**RESPONSE TO COMMENTS ON THE 1989 ANNUAL GROUND WATER MONITORING
REPORT FOR REGULATED UNITS AT ROCKY FLATS PLANT**

PREPARED FOR:
U.S. DEPARTMENT OF ENERGY
 Rocky Flats Plant
 Golden, Colorado
FIGURE 4-8

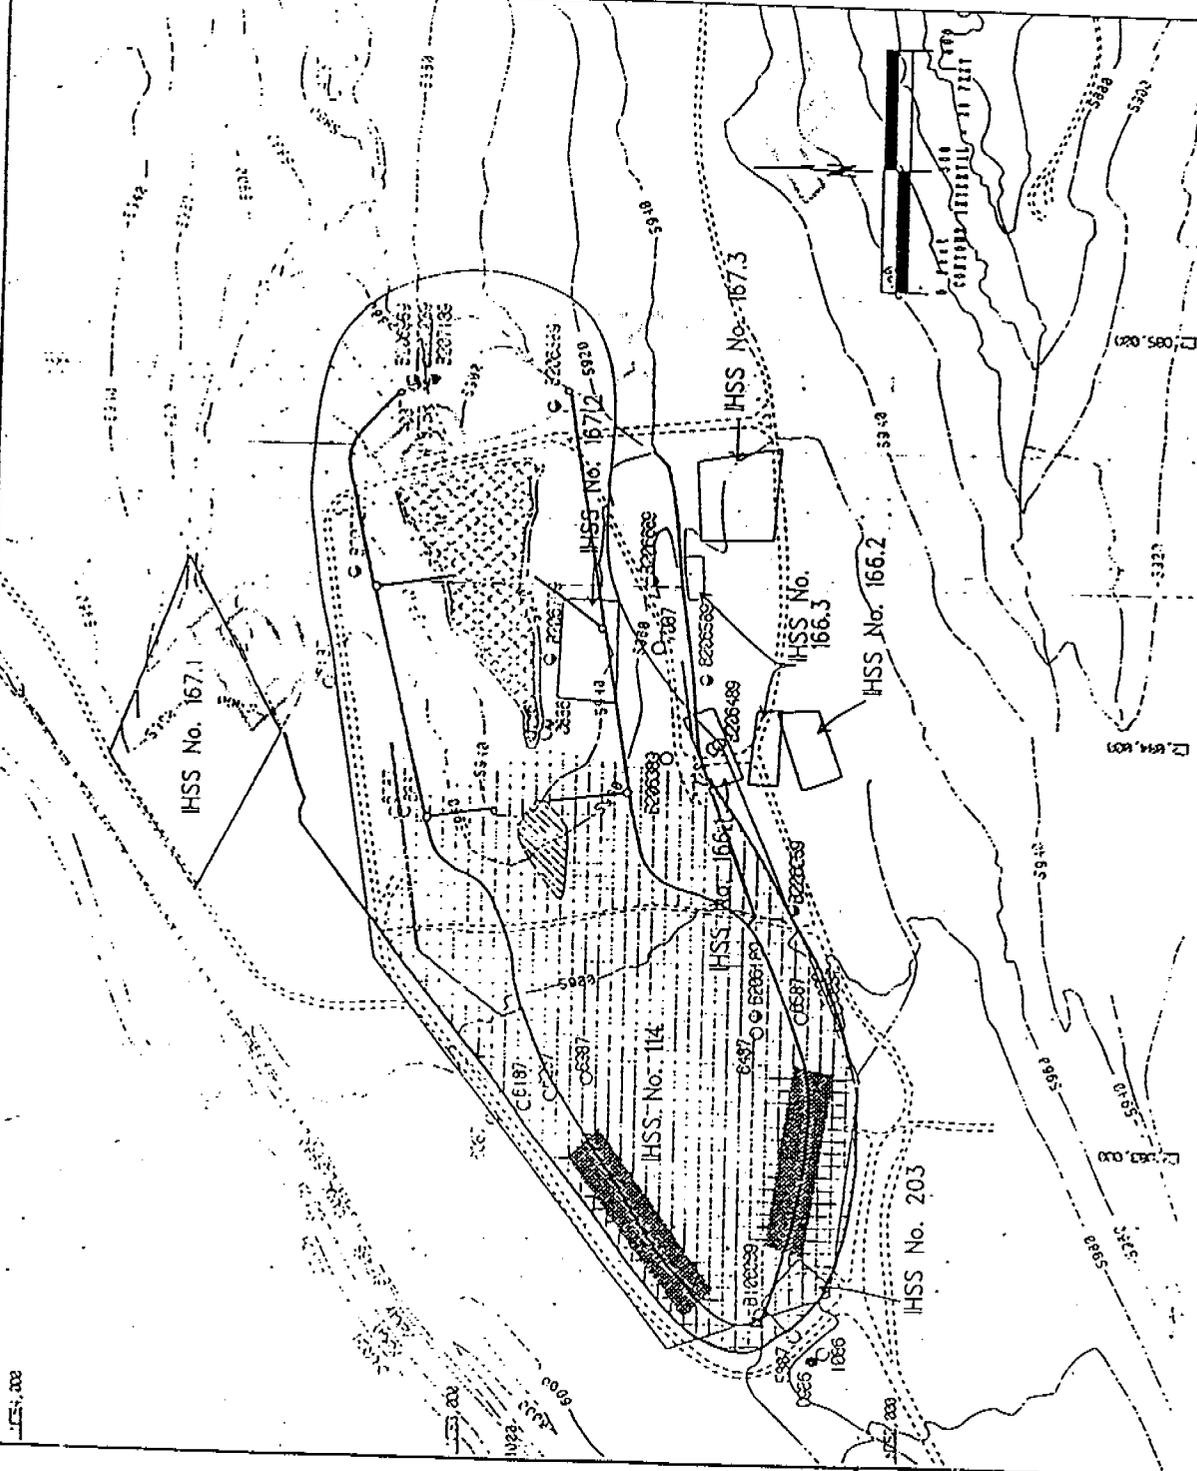
Response to Comment 16

Between 1977 and 1981, portions of the leachate and groundwater diversion system were buried during landfill expansion. The eastward expansion covered the discharge points of the leachate collection system into Pond No. 1. The west embankment and Pond No. 1 were covered in May of 1981 during further eastward expansion of the landfill. In 1982, two slurry walls were constructed to prevent groundwater migration into the expanded landfill area. These slurry walls were tied into the north and south arms of the groundwater diversion system. The approximate extent of the landfill material is shown on the attached Landfill Structures map.
